PROJECT: Hualapai ? Isaac Newton Single Family Residential

SUBMITAL: 1st

CITY OF LAS VEGAS		DATE:
INTER-OFFICE MEMORANDUM		August 10, 2020
TO: Land Development Services Department of Building & Safety		FROM: Albert Sung, P.E. Flood Control Project Engineer Department of Public Works
SUBJECT:	Drainage Study for:	COPIES TO:
	Hualapai & Isaac Newton Single Family Residential	VTN Nevada
Cross Streets:	NEQ of Hualapai Way & Isaac Newton Way	AMH Development West GC, LLC
File Number:	F:\Depot\DSMemos\DS5297A.doc	Bart Anderson, P.E., DevCo
Parcel Number:	138-07-401-001	
Zoning Action:	GPA-77926; MOD-77927; SDR-77928; TMP-77930 & VAR-77931	
FEMA Flood Zone	YES NO X	
Proposed Storm Drain	YES NO X

GRADING PLAN 2

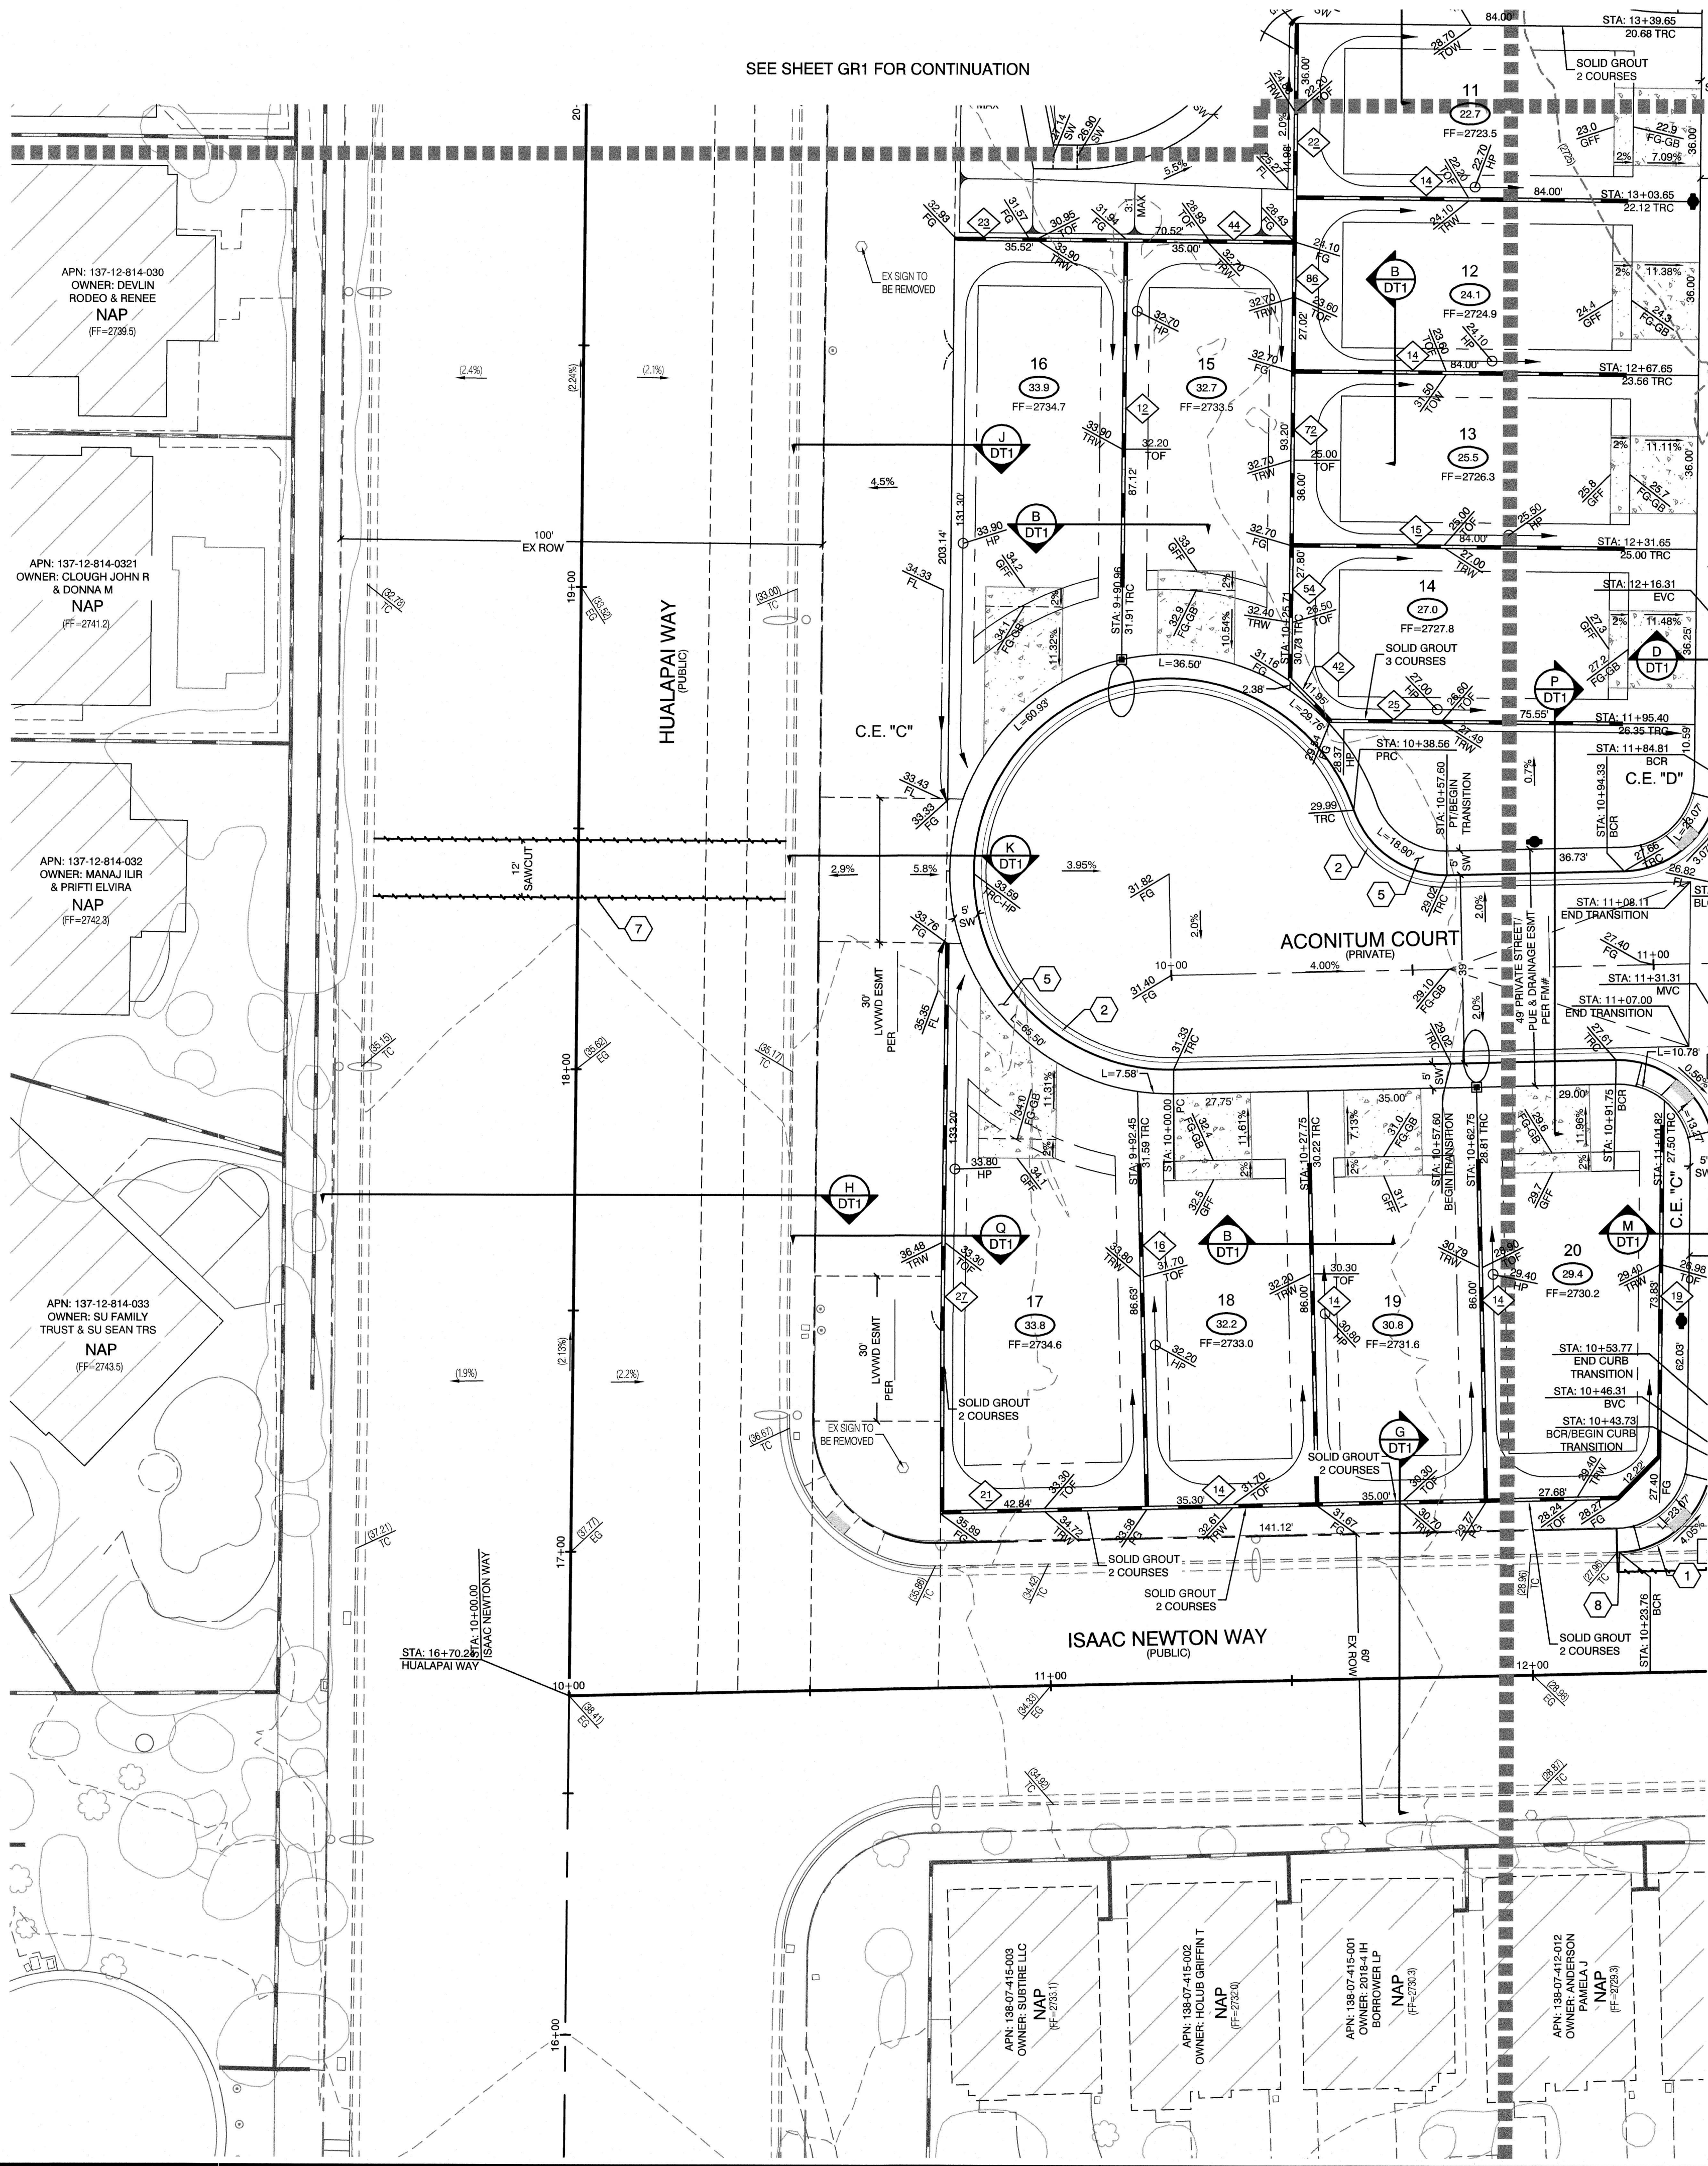
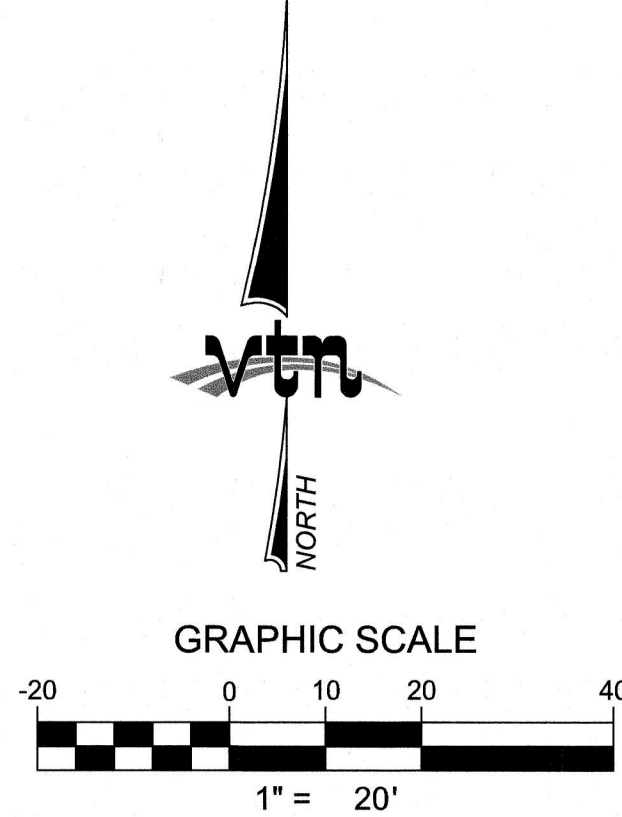
8. **Sheet GR1:** Show and label the slope in the bulb of *Roseum Court*. Note that the minimum slope in the bulb is 1%.
9. **Sheet GR2:** CE “F” must also be dedicated as a “Public Drainage Easement to be Privately Maintained by the HOA”.

10. **Sheet GR2:** Identify an existing drainage easement in the adjacent apartment complex to the east and label with recorded document or final map number on the grading plan.

11. **Sheet GR2:** Between CE “F” and the adjacent existing drainage easement, should there be a wrought iron fence/gate to separate the two communities? Provide as such in the next submittal.

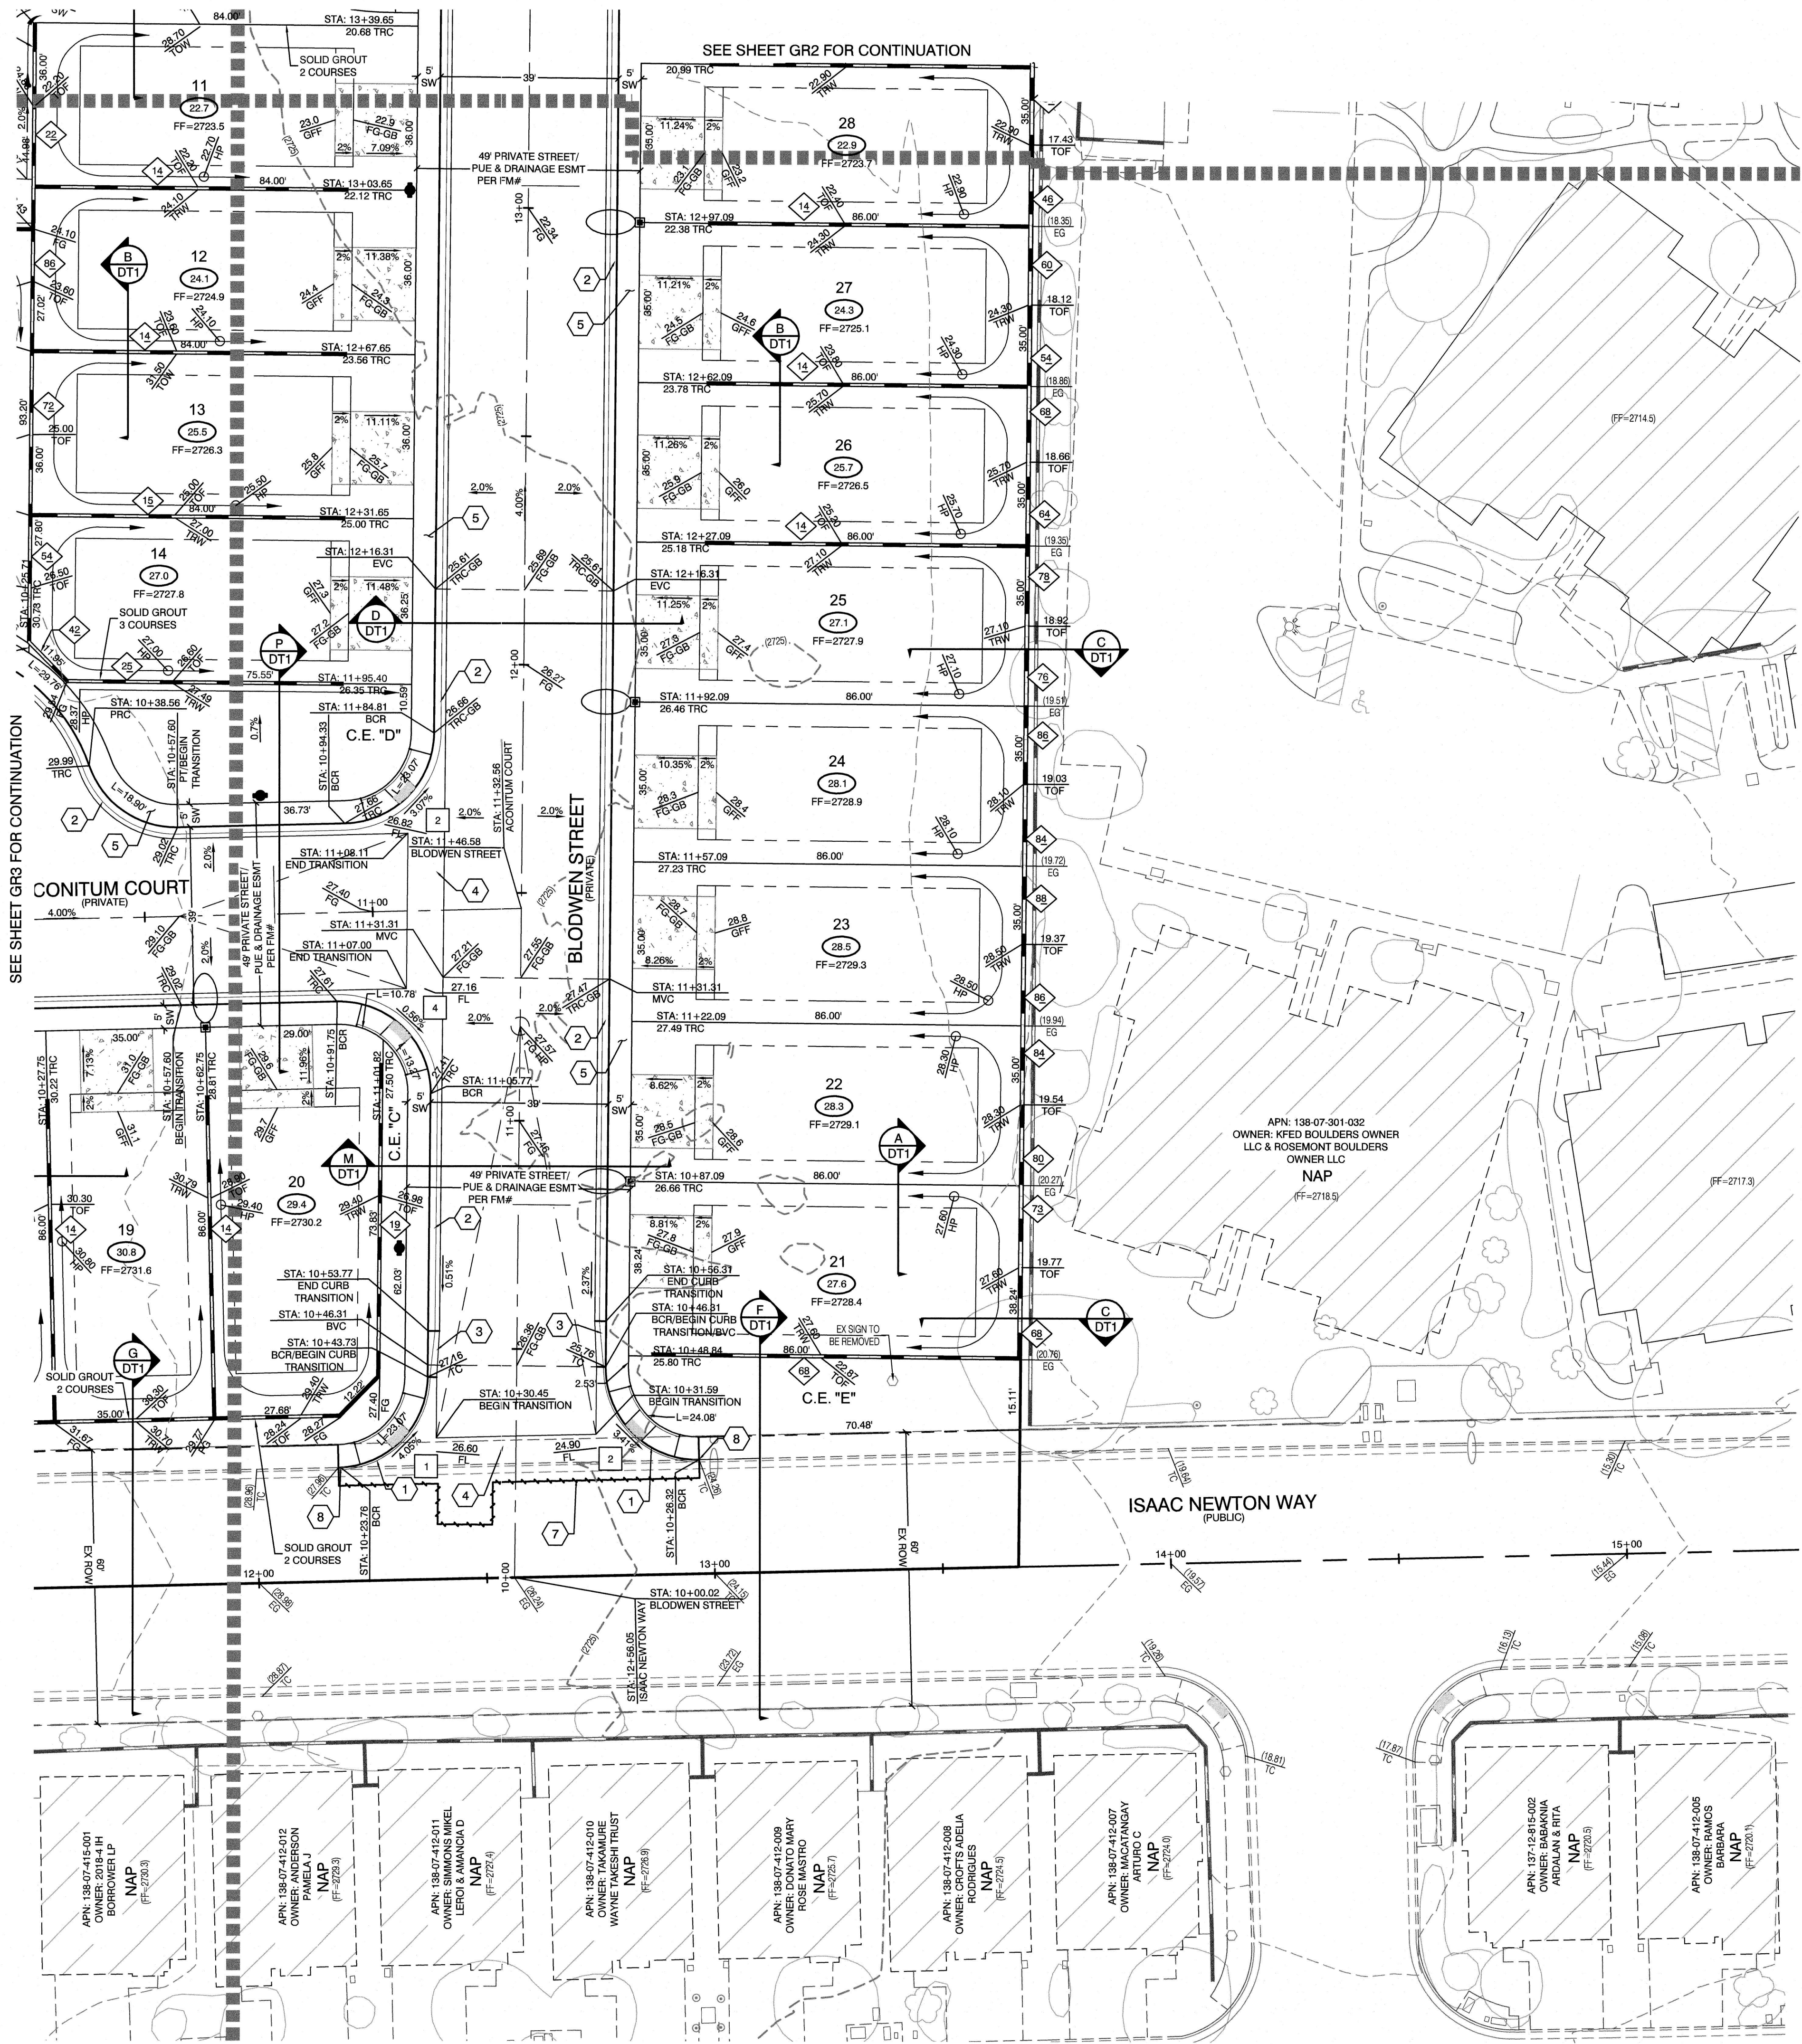
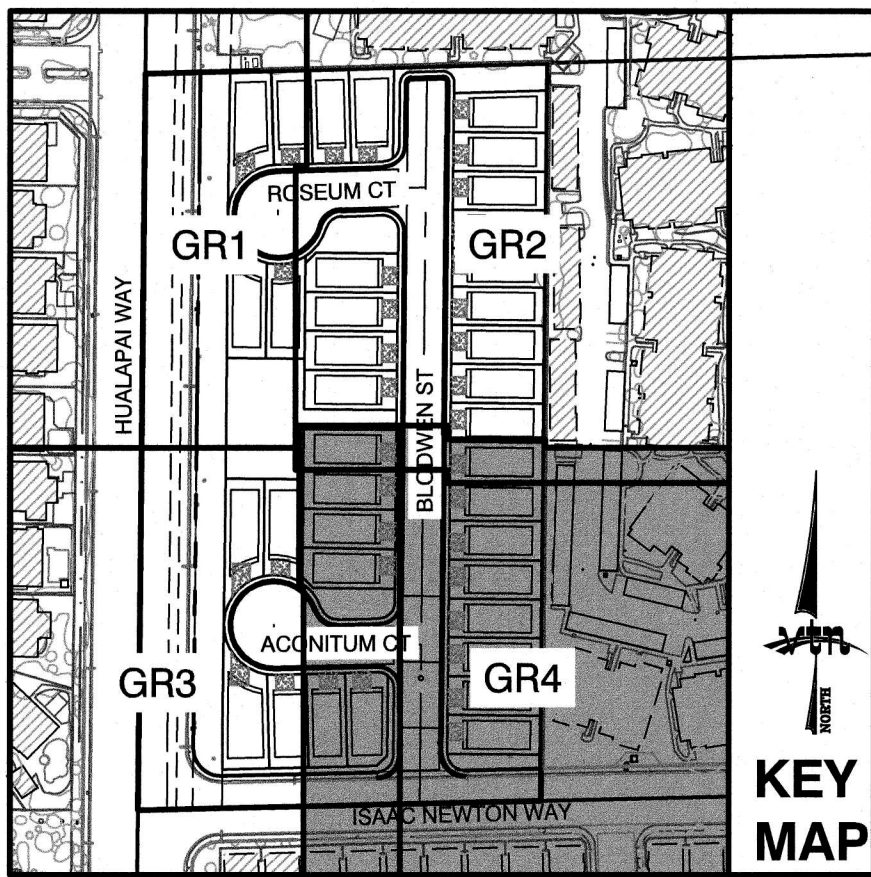
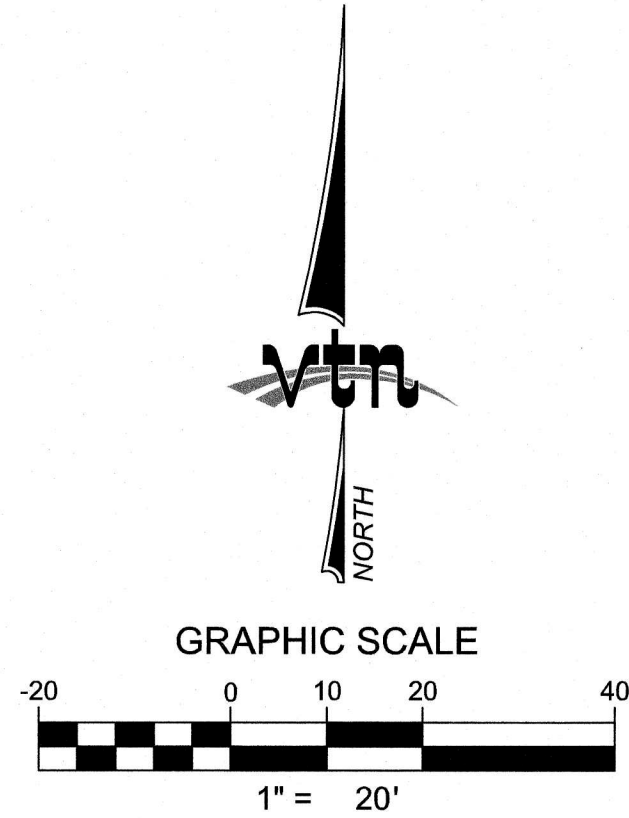
12. **Sheet GR3:** Show and label the slope in the bulb of *Aconitum Court*.
13. **Sheet GR3:** The linetype in Lot 16 appears that it doesn’t have a wall along *Hualapai Way*. Revise the linetype accordingly.

TYPICAL SECTION C
NTS

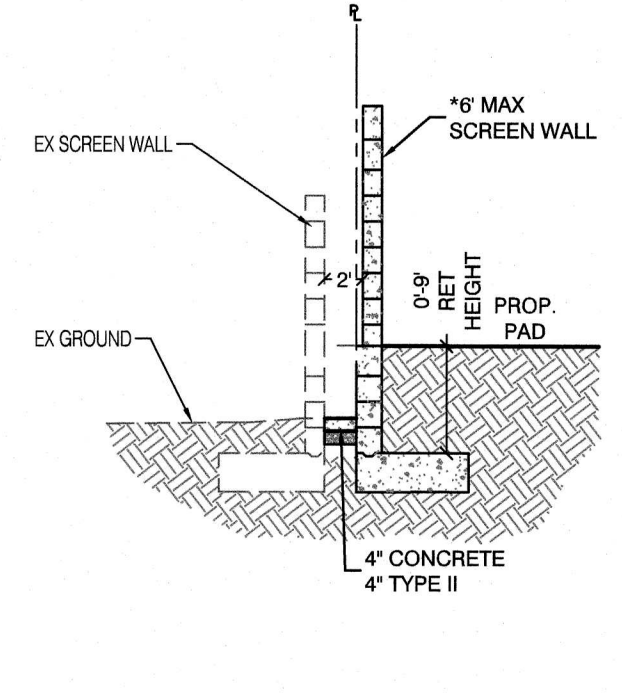
14. **Sheet DT1:** Typical Section C: A 2’-gap is proposed between an existing wall and the new wall. This will create a no-man land and difficult to maintain. Obtain direction from *City Planning* for possible mitigation prior to the final approval of the subject drainage study.

Please refer to Comment #14 in the drainage study comment letter. Section C on Sheet DT1 proposes a 2-foot gap between the adjacent property screen wall and proposed retaining wall. Flood Control has requested that we obtain direction from the Planning Department for possible mitigation due to maintenance concerns. Please also include direction for Comment #14 as requested by Flood Control to the engineer, if any.

Please note on sheet DT1, detail c, indicate two walls adjacent to one another, separated by a two-foot space between them.

- A) Will not increase the load on the walls; and
- B) Has been approved by the Departments of Planning and Building and safety.

TYPICAL SECTION I
NTS

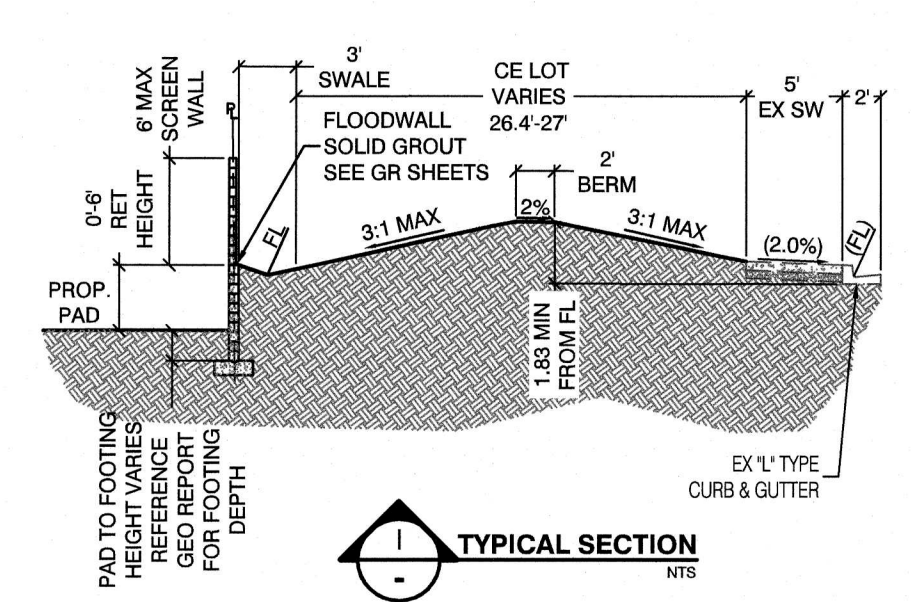
15. **Sheet DT1:** Typical Sections I, L and Q: Clearly specify the bottom 3 courses of the floodwall to be solid grouted 8”-CMU or equivalent thickness block.
